## HEATSINK MODULE ASSY.

CRESTAUDIO			
		TITLE			
		CA 6, 9 OUTPUT MODULE			
SHAWN	DATES	ELEC	FDE	DRAWING NO.	REV
EMERED	DATES				
QUALITY CONTROL	DATES				
REFERENCE	DATES				
SCALE		SHEET 2 OF 2

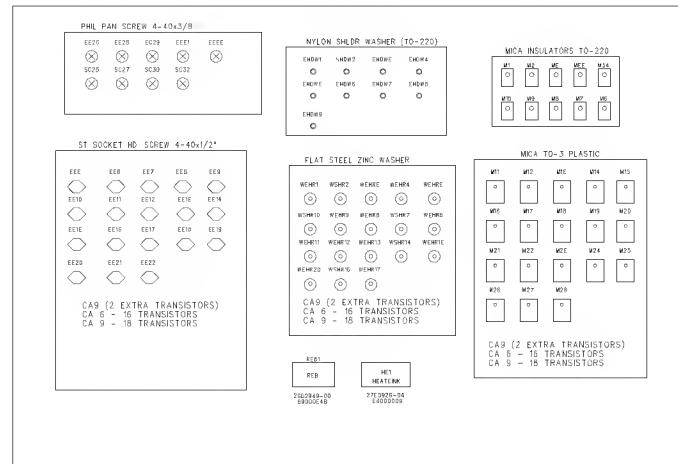
REV-1 BOARDS WERE NOT SENT OUT  
CA 6,99 OUTPUT WAS 7001 OUTPUT PCB  
SCHEMATIC MATCHES REV-1 EXCEPT FOR VALUES  
LAYOUT WAS DONE USING OLD DATABASE  
SEVERAL RESISTOR PINS 1 & 2 ARE SWAPPED BETWEEN SCHEMATIC AND PCB  
RESISTOR PINS FIXED ON REV-1
